**DEFENSE NUCLEAR FACILITIES
SAFETY BOARD**

RECOMMENDATION 2019-1 TO THE SECRETARY OF ENERGY
Uncontrolled Hazard Scenarios and 10 CFR 830 Implementation at the Pantex Plant
Pursuant to 42 U.S.C. § 2286a(b)(5)
Atomic Energy Act of 1954, as Amended

NUCLEAR EXPLOSIVE OPERATIONS WITH UNCONTROLLED HAZARDS AT THE PANTEX PLANT¹

Pantex Plant Special Tooling Program Review

Figure 1. *Cracked Safety Catches in the W76 Aft Disassembly Fixture, 076-2-0382 [26].*

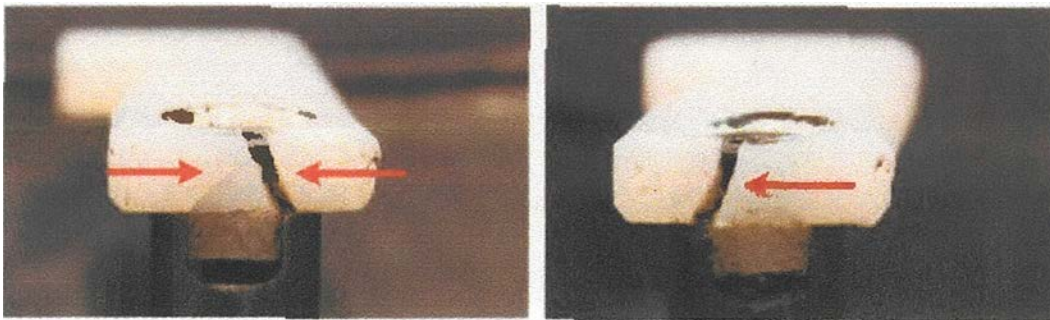
- *Safety Catches*—The staff review team evaluated the use of W76 vacuum lifting fixtures and the 2015 issue in which cracks were identified in vacuum lifting fixture safety catches (see Figure 1). The safety catches are a secondary feature to prevent a drop of high explosive charges should vacuum fail on the lifting fixture. The staff review team is concerned that actions taken to-date may not prevent recurrence of cracking of safety catches. Pantex continues to rely on production technicians to identify cracking during routine prior-to-use inspections. The staff review team believes that application of an ISI or introduction of a specific step within the nuclear explosive operating procedure to check for safety catch damage prior to use would bolster the reliability of this check. Alternatively, the safety catches could be redesigned, substituting a material with a lower likelihood of cracking (e.g., appropriately coated metal).
